**Re: Official Complaint against Registered Legislative Advocate JAMES DAVID FAUL  
aka Jim D. FAUL IN CONNECTION with A PUBLIC MATTER before the City Council and  
TO AN OFFICIAL GOVERNMENT AGENCY.**

The City has completed its review of the above cited plan check application for conformance with applicable policies and regulations. As indicated on the corrections below, the plans must be revised before a building permit can be issued.

The Building and Safety Division has completed its 5th review of the plans dated 8/02/2017, submitted in conjunction with the above cited Activity Number. The following corrections are required to comply with the City's rules and regulations:

DATE / 03/10/17 CHECKED BY / DATE SHEET 3 OF 11

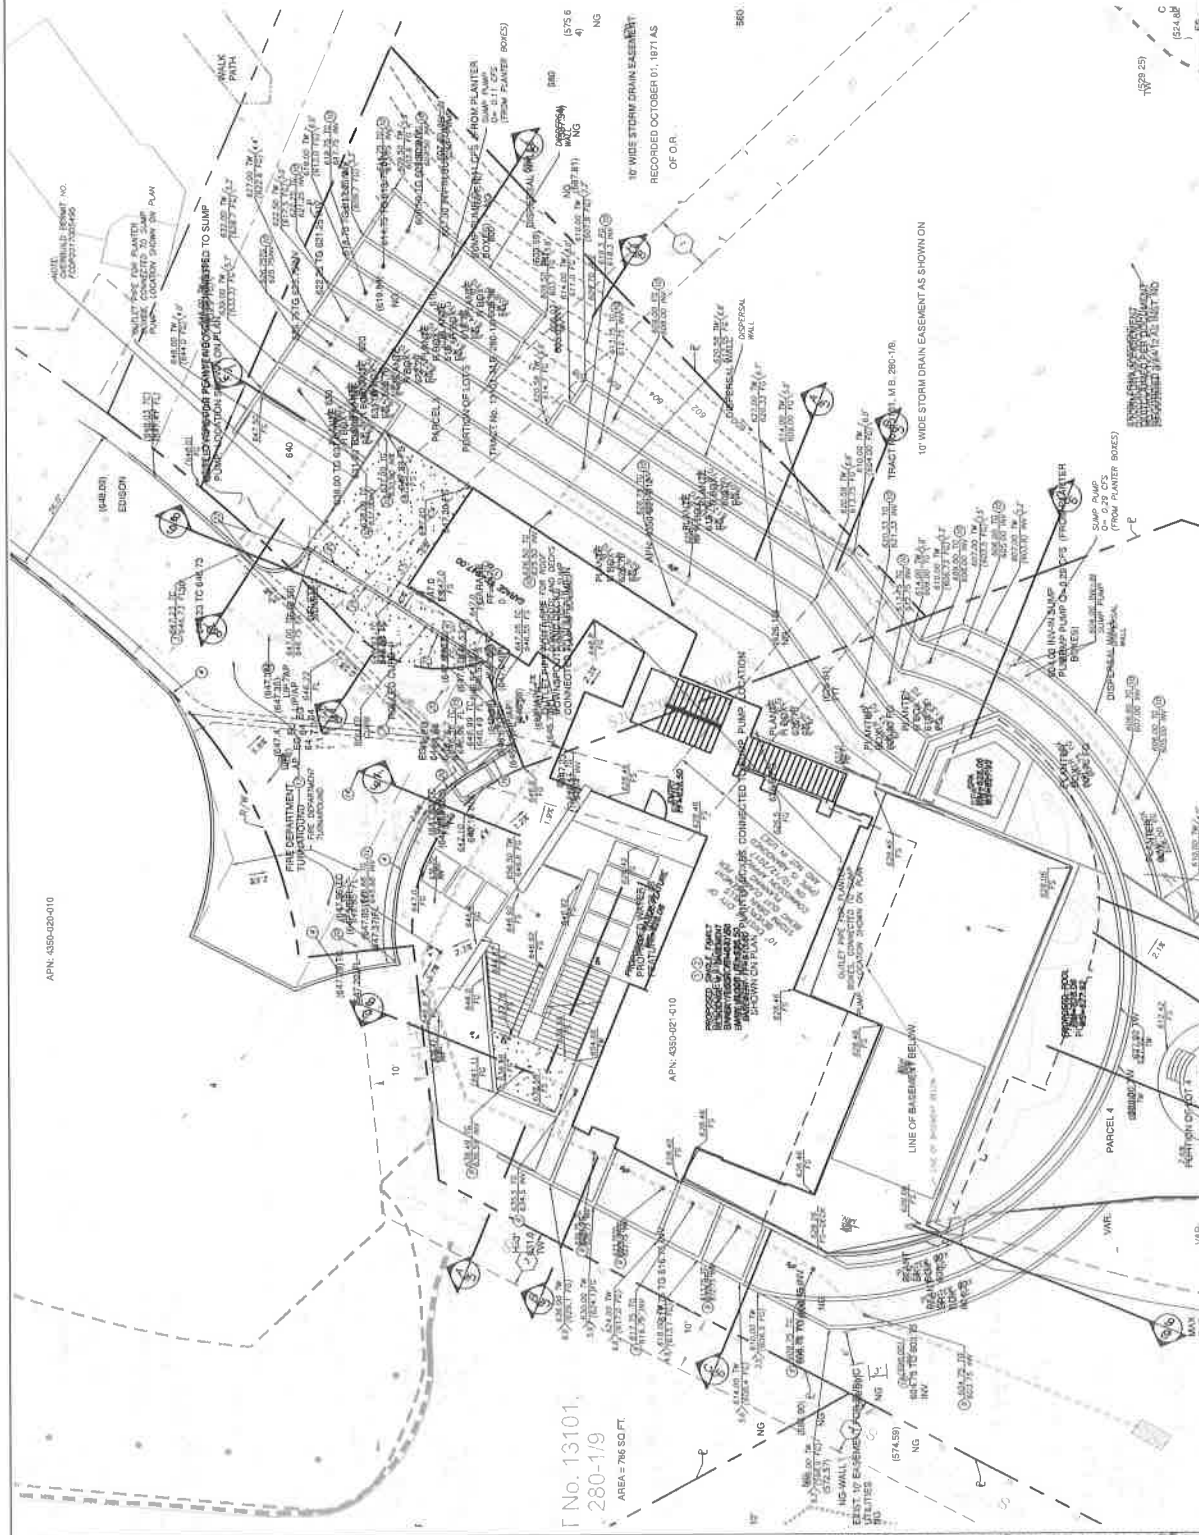
**Sheet 3 of 11: Show that the pad and deck drains go through sump to street.**

Sheet 3 of 11: Show that the pad and deck drains go through sump to street.

SECTION H  
HORIZONTAL SCALE 10'  
VERTICAL SCALE 10'

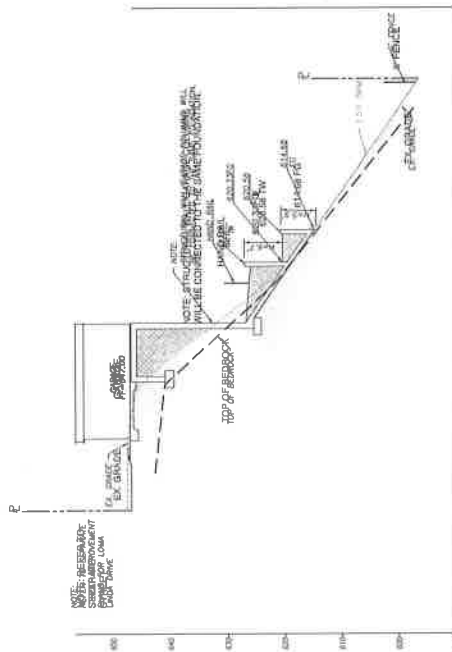
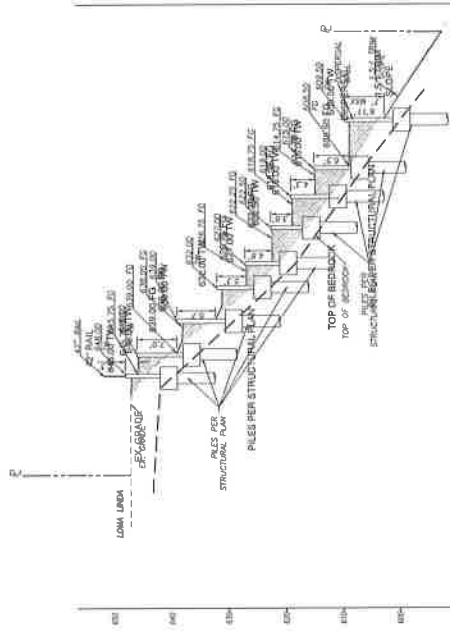
(1) Section I shows a wall with no fill. The architectural plans show this wall as having fill. Please verify.

Page 17 of the 2/17/16 soils report is requiring that any fill remaining on the east facing slopes below the garage and residence be trimmed to expose the native soils as shown typically on section H. The civil/grading plans and soils removal calculations must show this fill trimming. The soils engineer must sign these plans to confirm that all fill that must be removed is shown on these plans. Page C004 is not showing this fill trimming.
